# Citizen Concerns I-16/I-75 Interchange Design

Project # NH-IM-16-1(92), NH-IM-16-1(131), NH-IM-75-2(177), & NM-16-1(104)  
P.I. # 311000, 311005, 311400, & 311410

Shirley Hills & North Highlands  
Neighborhood Associations  
February 2003

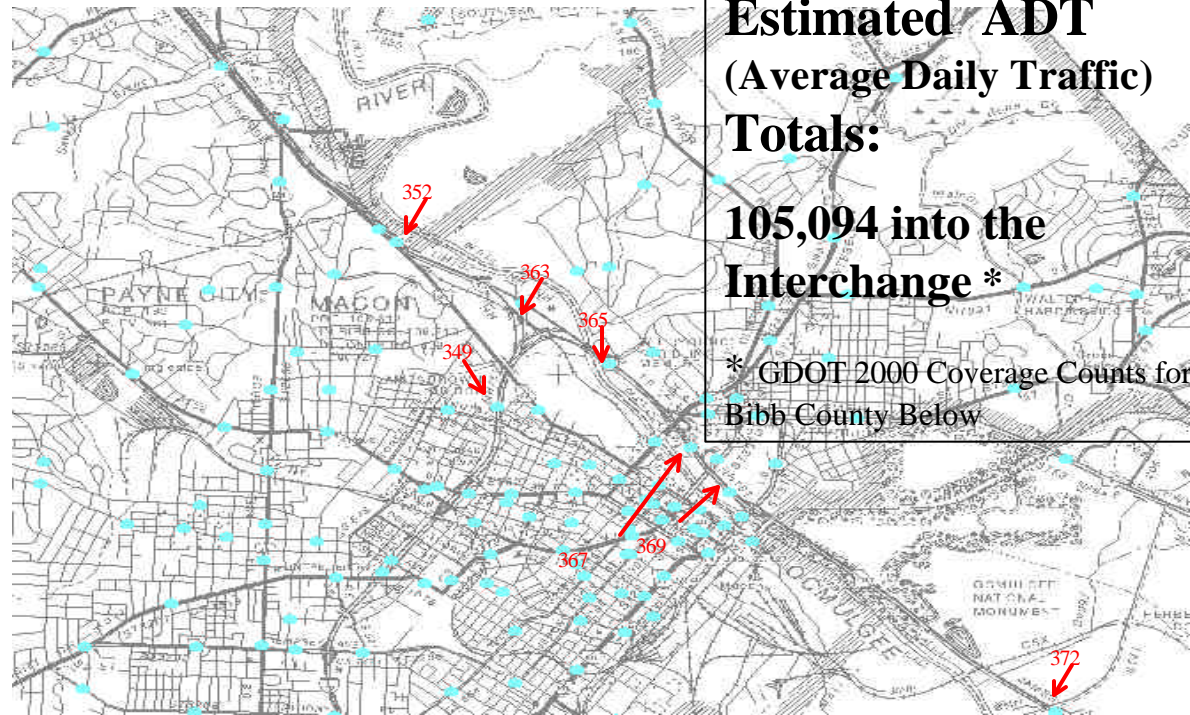
- ADT - Average Daily Traffic
- Estimated ADT Counts for the Interchange presented by Moreland/Altobelli and GDOT do not appear to coincide with actual collected GDOT Data
- The ADT counts from I-75 at Pierce Avenue and Hardeman Avenue combined with the ADT counts on I-16 at Spring Street in a single direction, into or out of the split, is the actual amount of traffic through the Interchange
- Estimated future Traffic (2025) by Moreland/Altobelli and GDOT appear to have used increased current traffic number to achieve a higher increase in vehicles

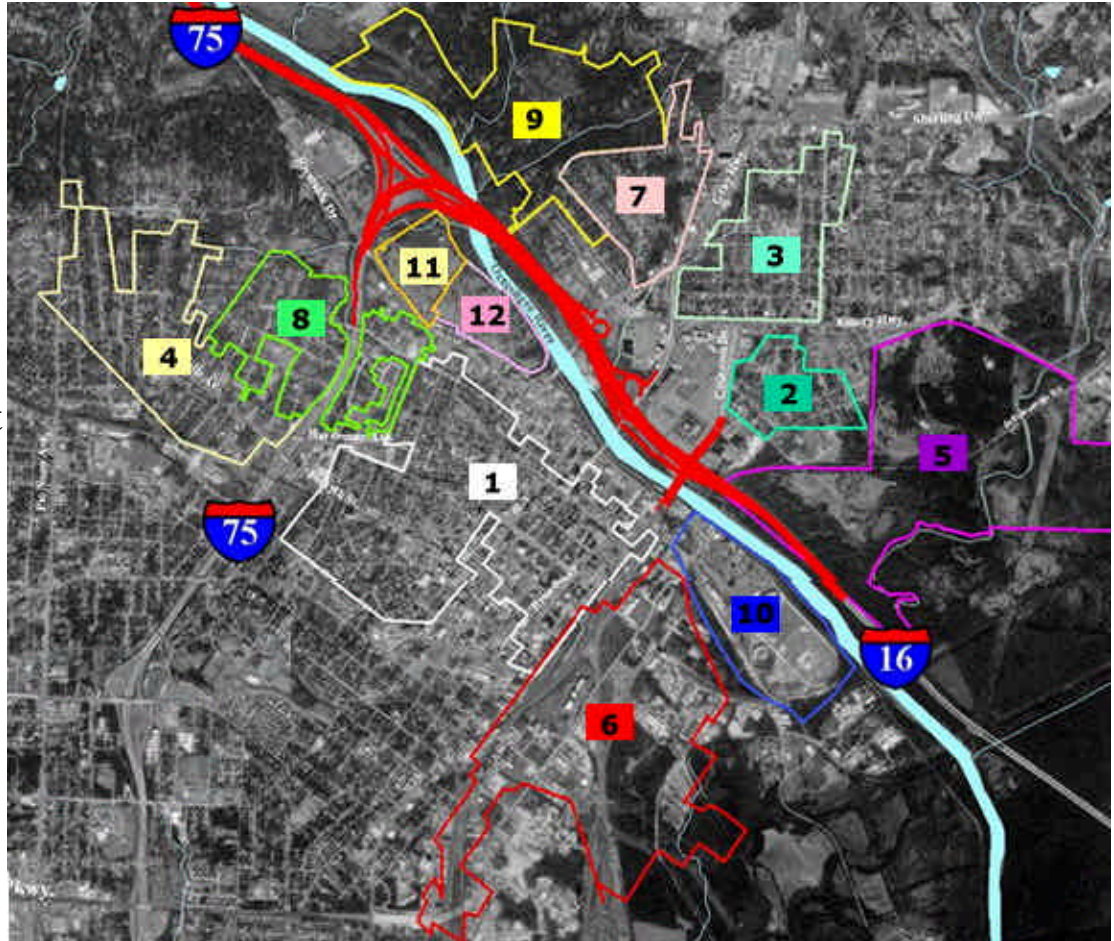
- Historic Areas

- Rose Hill Cemetery
- Riverside Cemetery
- Shirley Hills Historic District
- North Highlands Historic District
- Pleasant Hill Historic District
- East Macon Historic District
- Macon Historic District
- Vineville Historic District
- Fort Hill Historic District
- Central City Park
- Macon Railroad Industrial District
- Ocmulgee National Monument

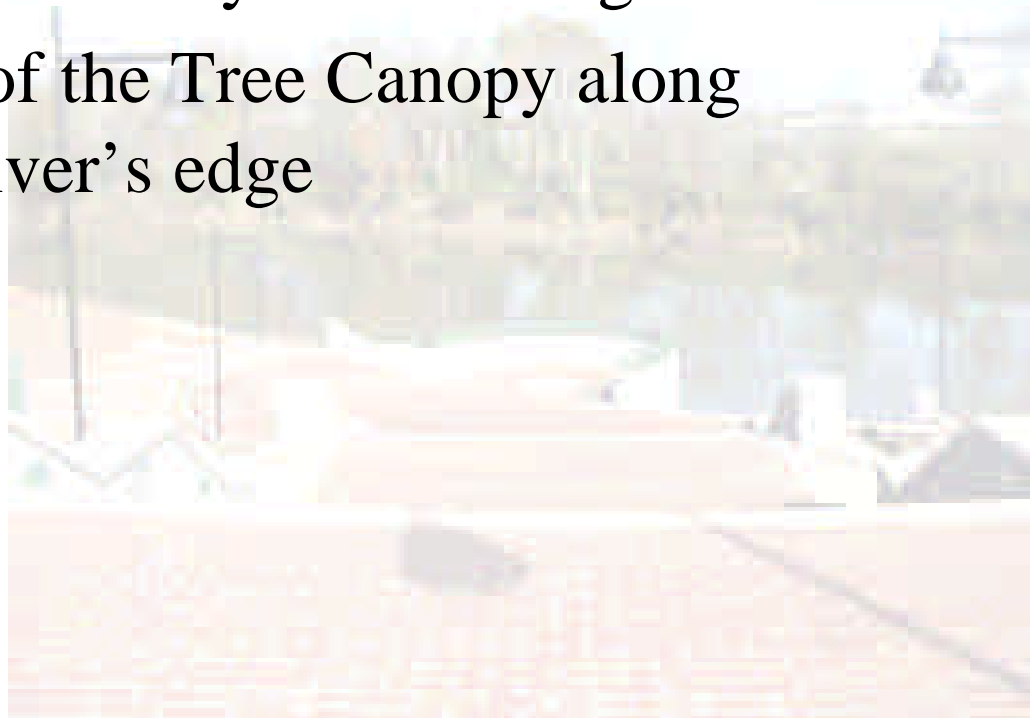
- Noise Barriers

- Only useful within a small area from roadway (200 to 300 feet) and a small reduction in sound (less than 20 dB)
- Unsightly walls will “bounce” sound into Rose Hill Cemetery, Riverside Cemetery, Macon Historic District, and Pleasant Hill Historic District
- 20 foot wall on Bridges will limit sight of the Ocmulgee River from Roadway as well as extend overall height of Bridge Structure to 90 feet above the River’s edge (Tom Moreland Interchange Bridges are approximately 90 feet)

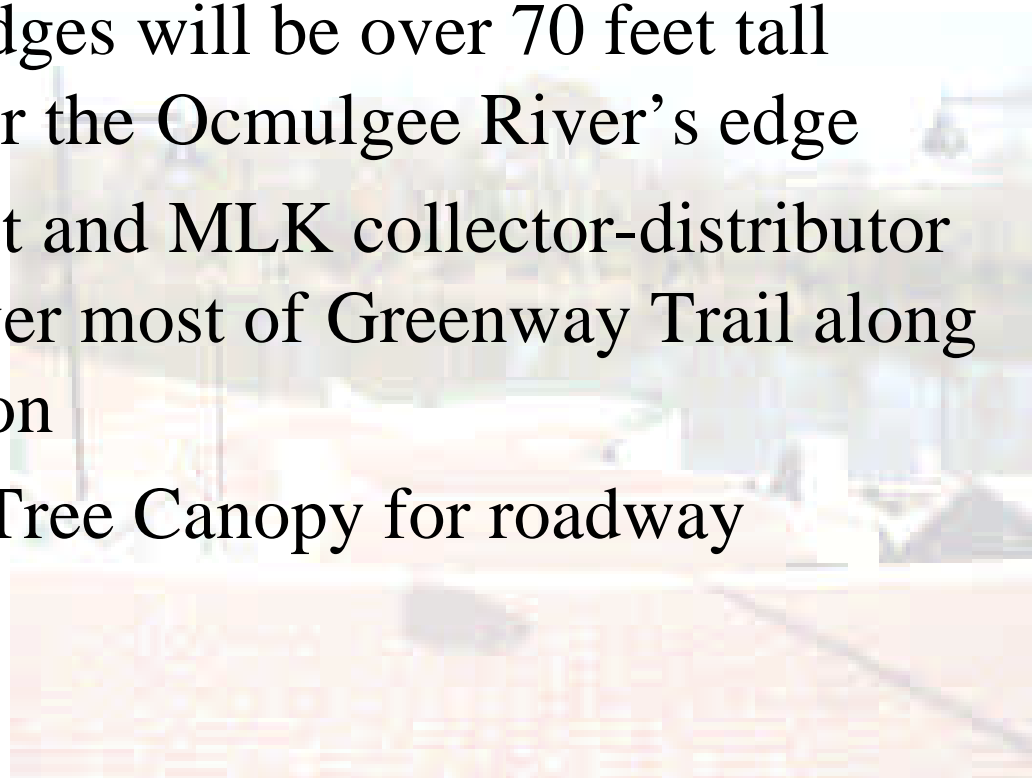
- Visual Impact
  - Fly-over Bridges will be over 70 feet tall towering over the Ocmulgee River's edge
  - Second Street and MLK collector-distributor road will cover most of Greenway Trail along river in Macon
  - Removal of Tree Canopy for roadway construction

Fly-over Bridges Looking  
North from Greenway

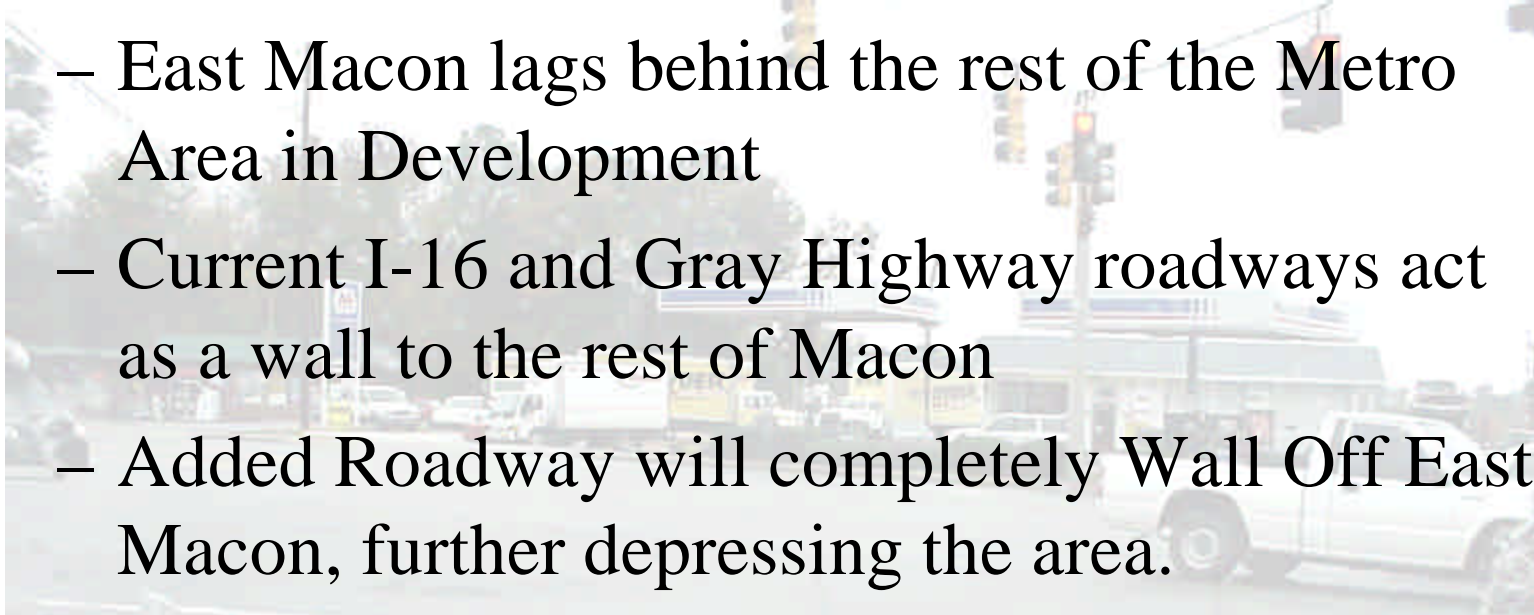
- Visual Impact
